ATEC
 FRAMEWORK DEVELOPMENT PLAN
 AURORA, COLORADO

MASTER PLAN NARRATIVE

PUBLIC IMPROVEMENTS PLAN

Sheet Title
 OVERALL
 LAND USE MAP

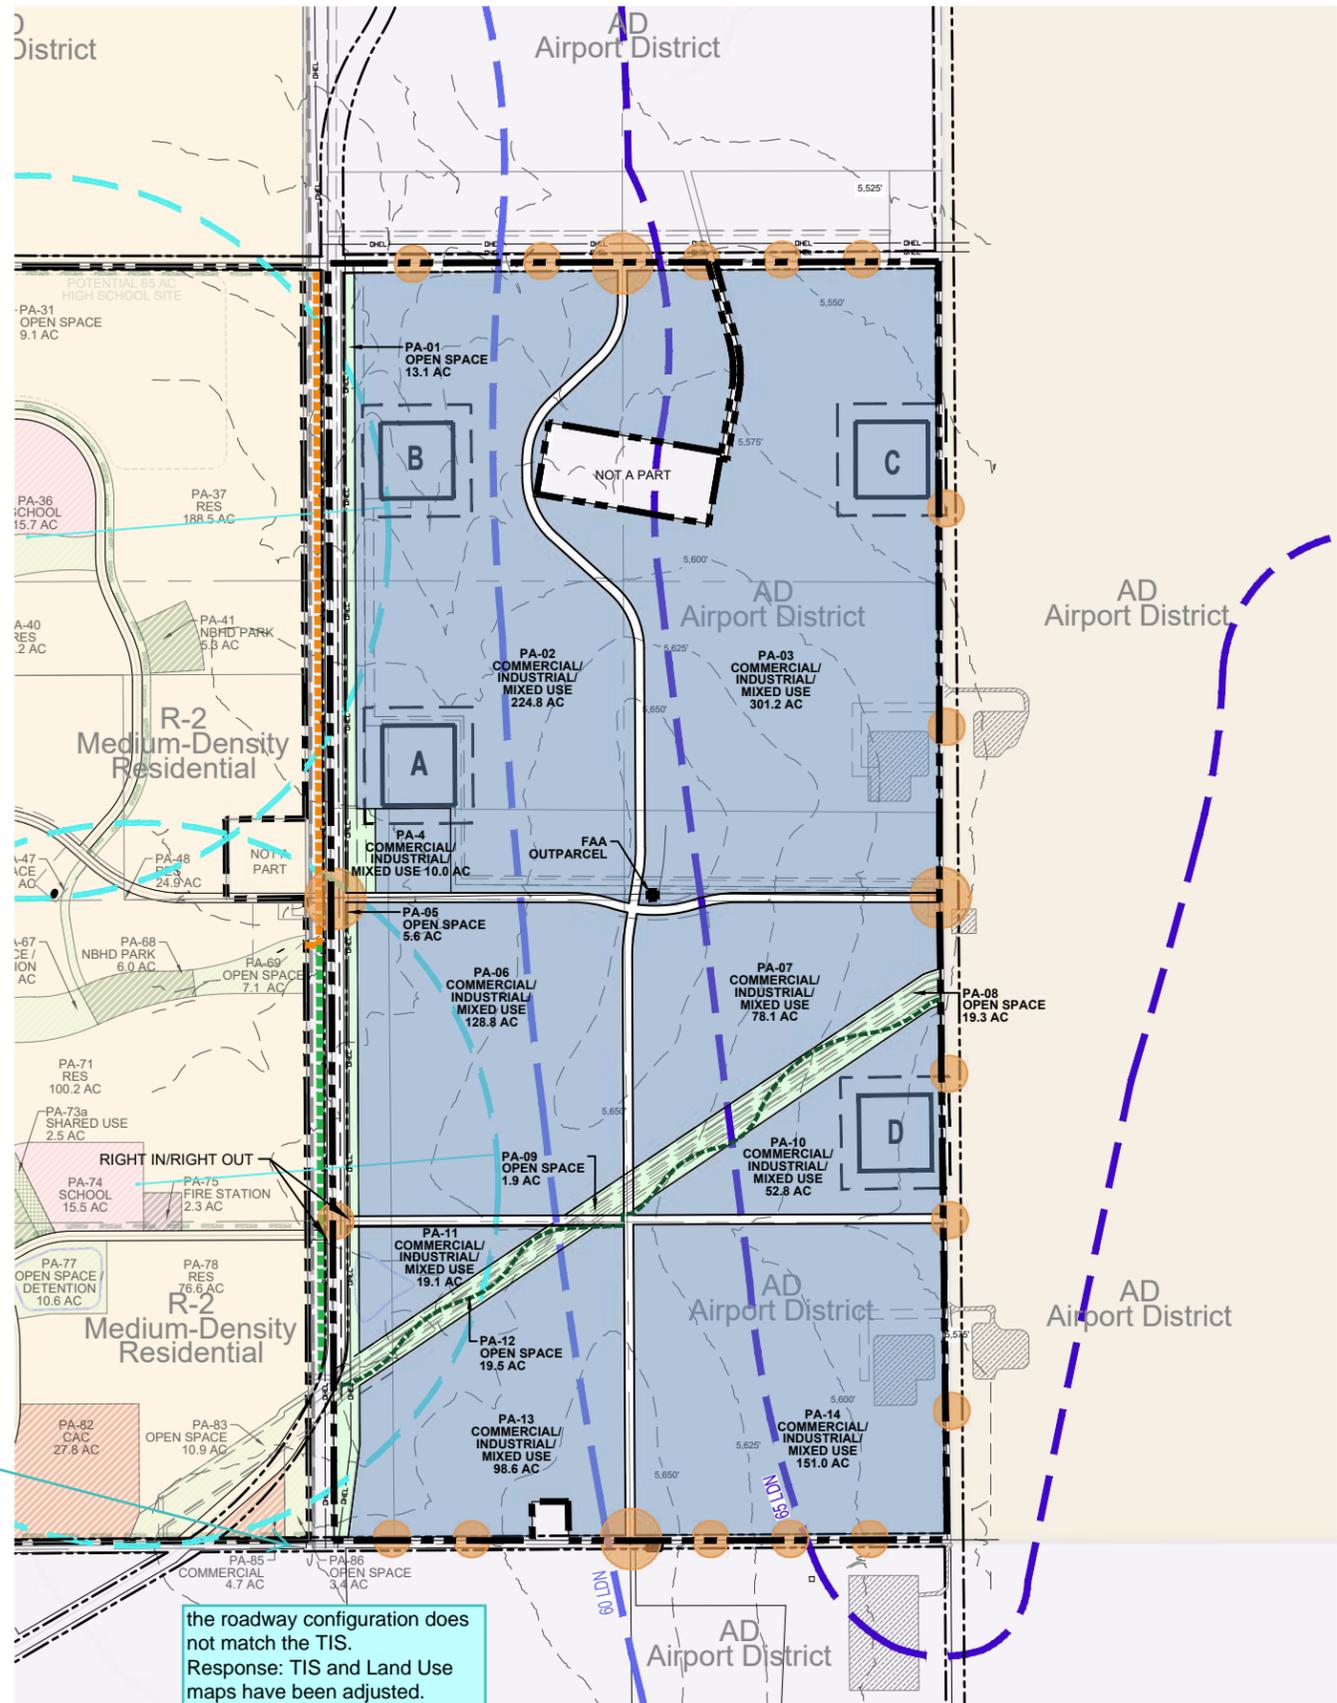
it is unclear what the interim condition is vs. ultimate condition and timing.
 Response: Intersection has been updated to reflect the ultimate condition of the "Divergent Diamond Interchange".

the roadway configuration does not match the TIS.
 Response: TIS and Land Use maps have been adjusted.

Sheet Title
 OVERALL OPEN SPACE & CIRCULATION MAP

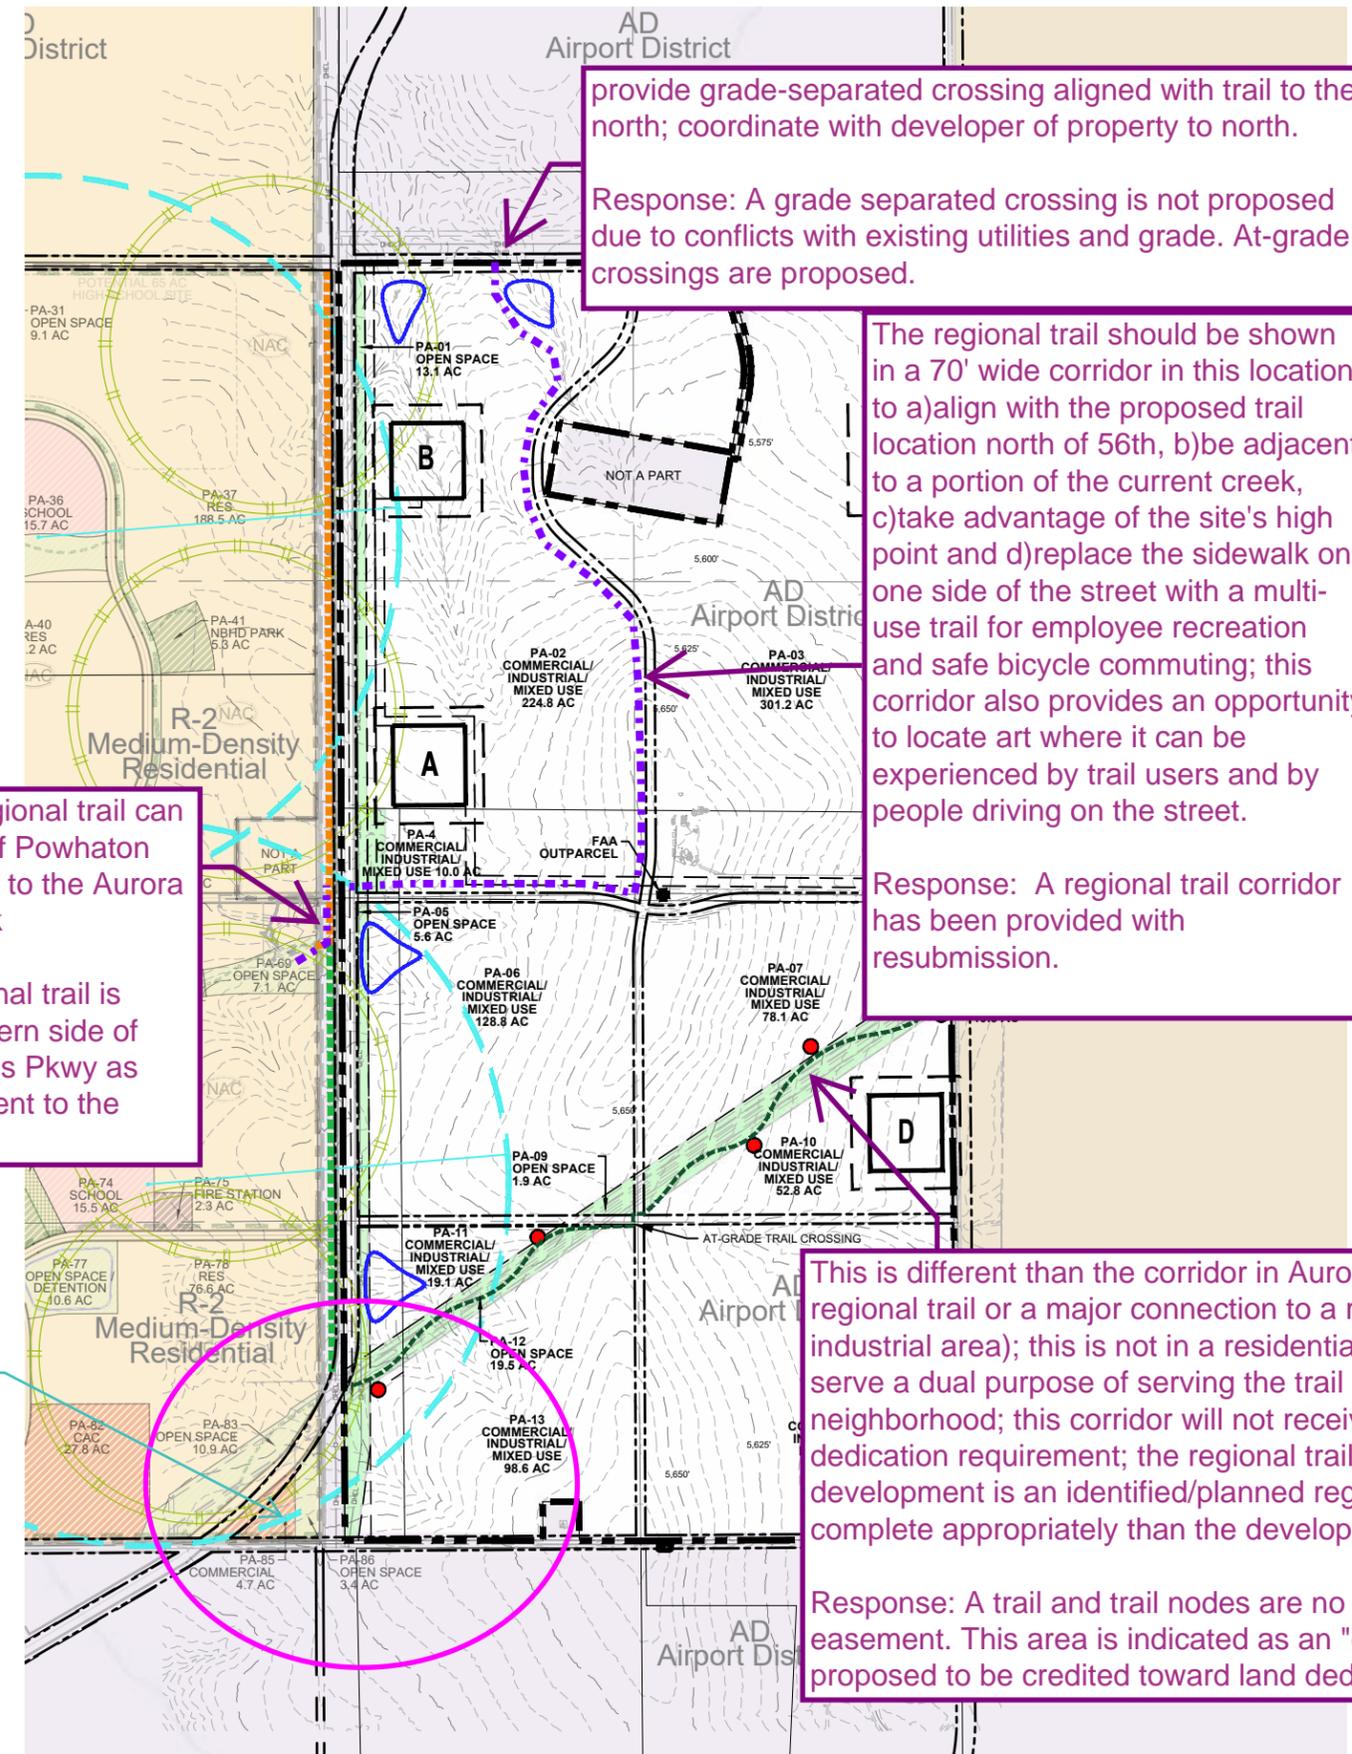
provide grade-separated crossing aligned with trail to the north; coordinate with developer of property to north.

The regional trail should be shown in a 70' wide corridor in this location to a) align with the proposed trail location north of 56th, b) be adjacent to a portion of the current creek, c) take advantage of the site's high point and d) replace the sidewalk on one side of the street with a multi-use trail for employee recreation and safe bicycle commuting; this corridor also provides an opportunity to locate art where it can be experienced by trail users and by people driving on the street.

This stretch of the regional trail can be on the west side of Powhaton and make connection to the Aurora Highland trail network

the plans need to reflect the realignment of roadways per TIS. the open space/trail layout will be significantly modified.

Response: A grade separated crossing is not proposed due to conflicts with existing utilities and grade. At-grade crossings are proposed.

Response: A regional trail corridor has been provided with resubmission.

Response: The regional trail is proposed on the eastern side of Powhaton/Aerotropolis Pkwy as well as internal adjacent to the north/south collector.

Response: Plans reflect the ultimate condition of the proposed "Divergent Diamond Interchange" at this location.

PRIMARY ENTRY MONUMENTS PLAZA

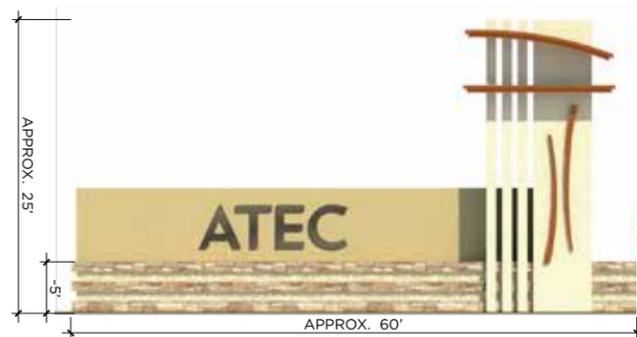
include location criteria appropriate for the location of these signs or provide a map of locations, otherwise the addition of large monument signs shall be subject to a Master Plan amendment

Response: A key map has been provided.

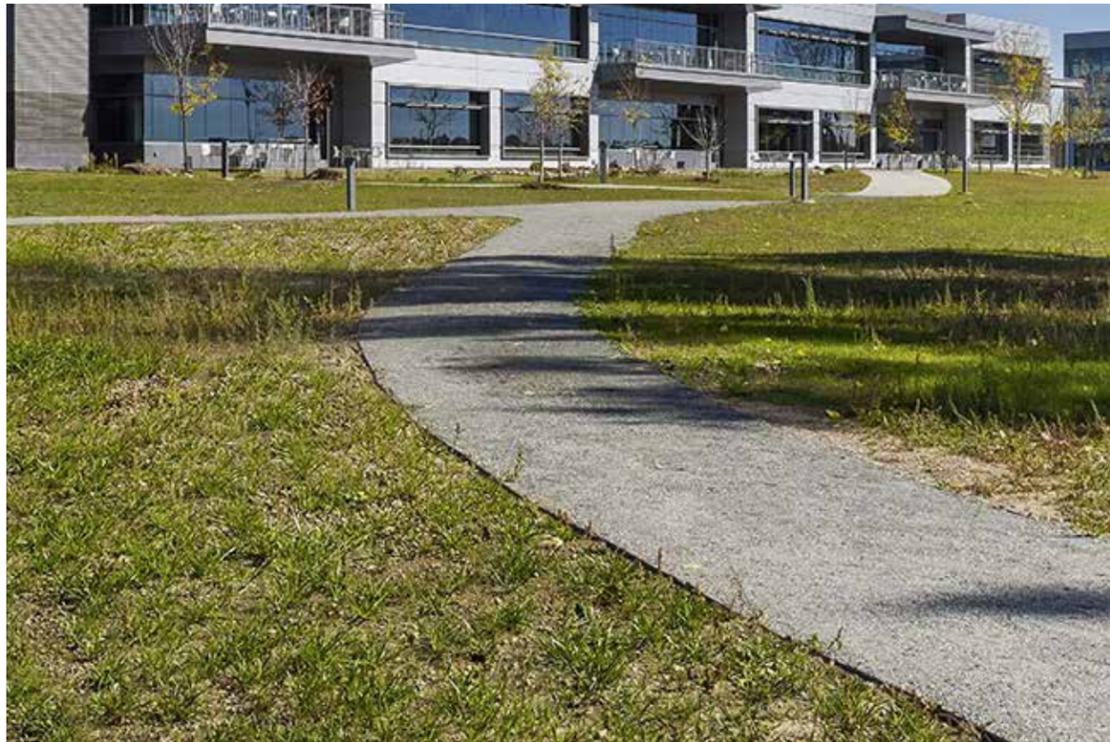
where shown, this is not a regional trail; call it a community trail

not an acceptable location; see Tab 9 Open Space, Circulation & Village Plan

Response: Revised.

Response: Adjusted

PUBLIC IMPROVEMENT PLANS
 OVERALL INFRASTRUCTURE

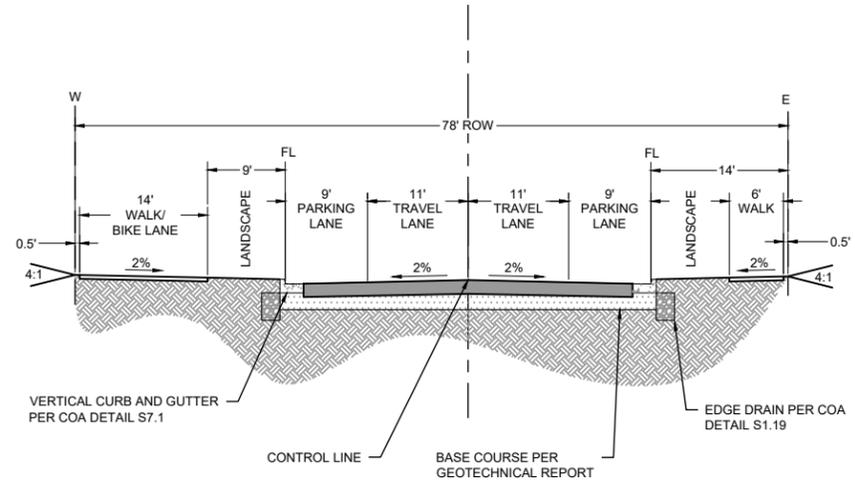
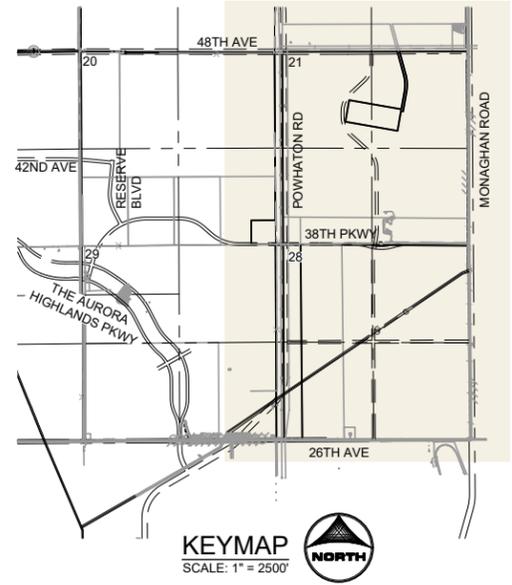
This section is 4 lanes (with additional aux lanes at Powhatan Rd)

Intersection/roadway alignment in this area is not yet defined at this time (add note)

Note added to Overall Infrastructure Plan

FOUR-LANE ARTERIAL

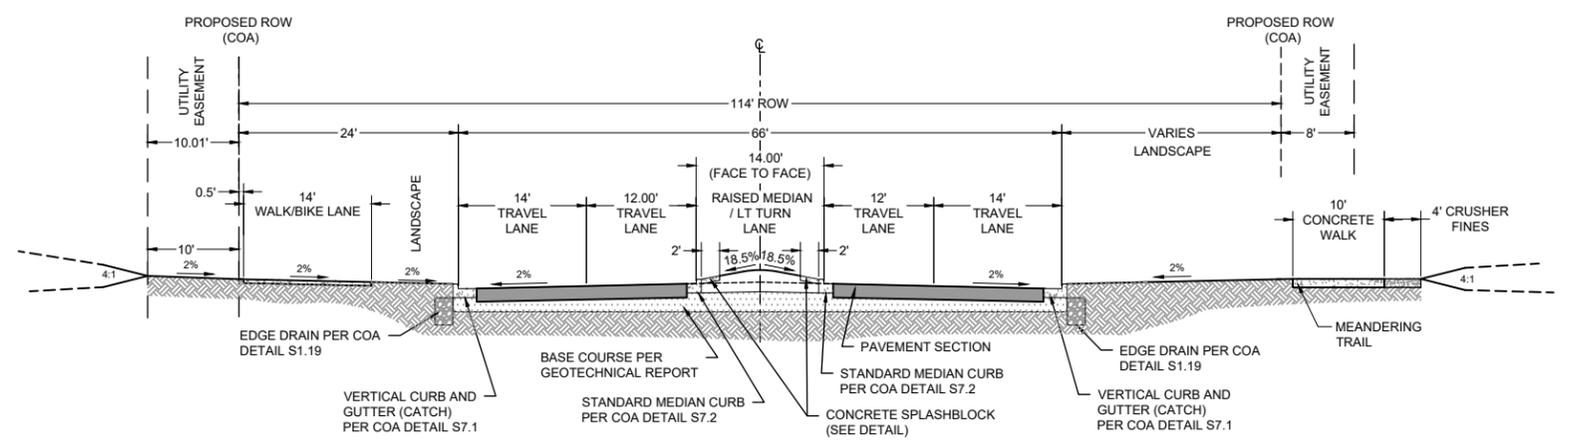
Can use this section for 38th between Powhaton Rd & N/S collector

THREE-LANE COLLECTOR

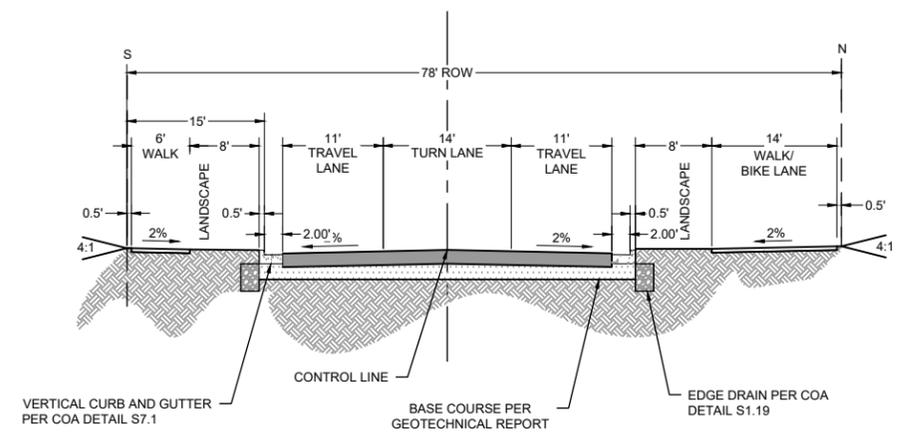
This typical section no longer applies to the proposed improvements. Please see updated plans for typical sections

SIX-LANE ARTERIAL

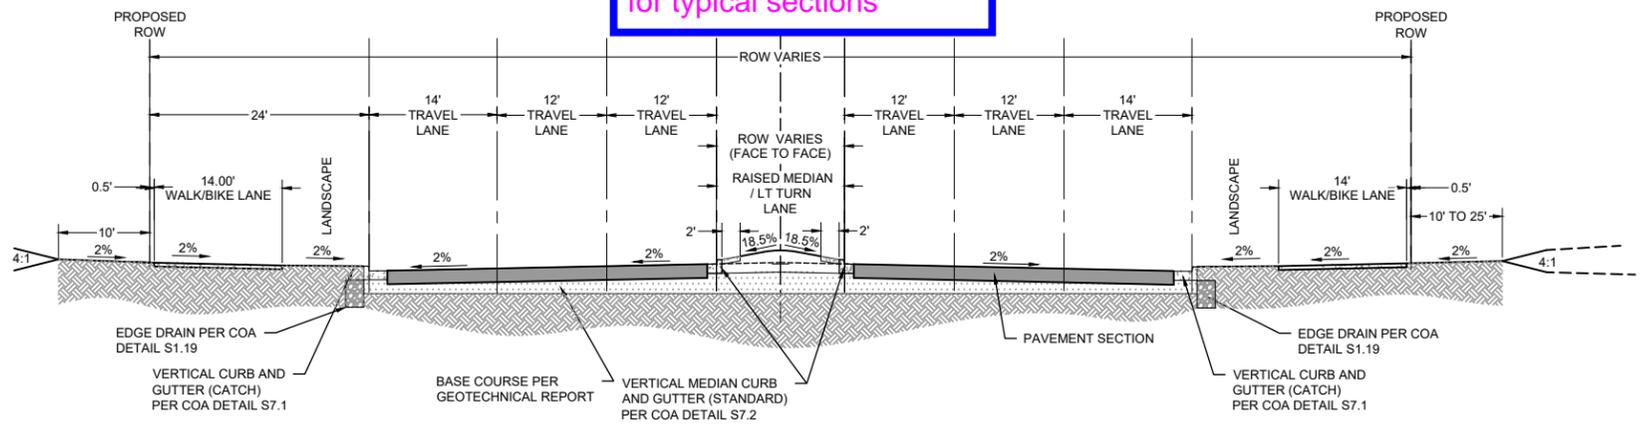
Add note "Sections depicted here do not include auxiliary lanes. Auxiliary lanes are required at multiple locations and may be in Master Traffic Impact Study or later Detailed Traffic Impact Studies."

Note added

PUBLIC IMPROVEMENT PLANS
 PLANNING AREA 6 - INFRASTRUCTURE

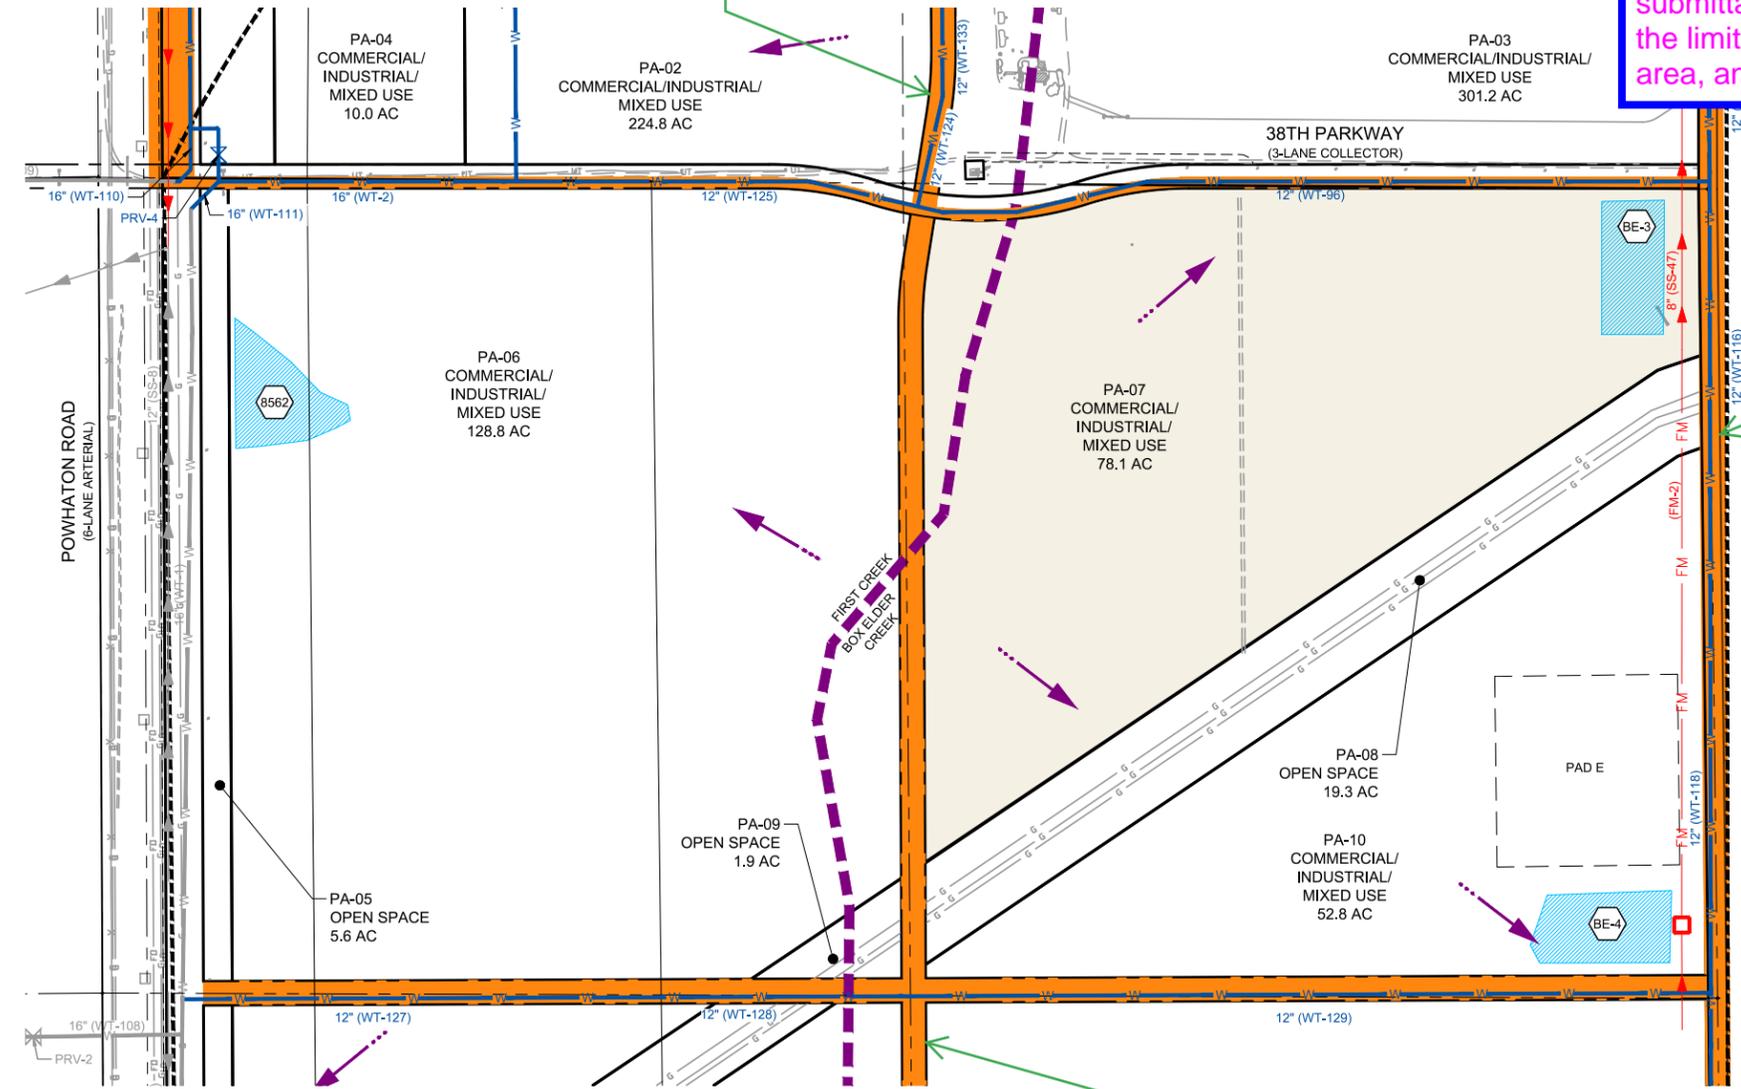
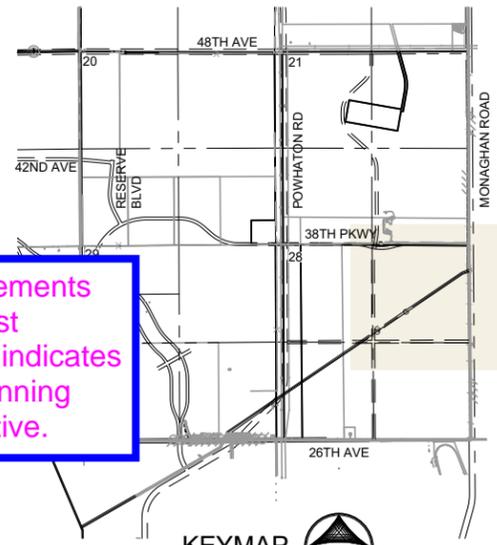
Intersection/roadway alignment in this area is not yet defined at this time (add note)

The narrative says the north south road is only to 38th

Note added to Overall Infrastructure Plan

Planning areas and associated improvements have changed significantly since the last submittal. The current narrative clearly indicates the limits of improvements for each planning area, and the exhibits reflect this narrative.
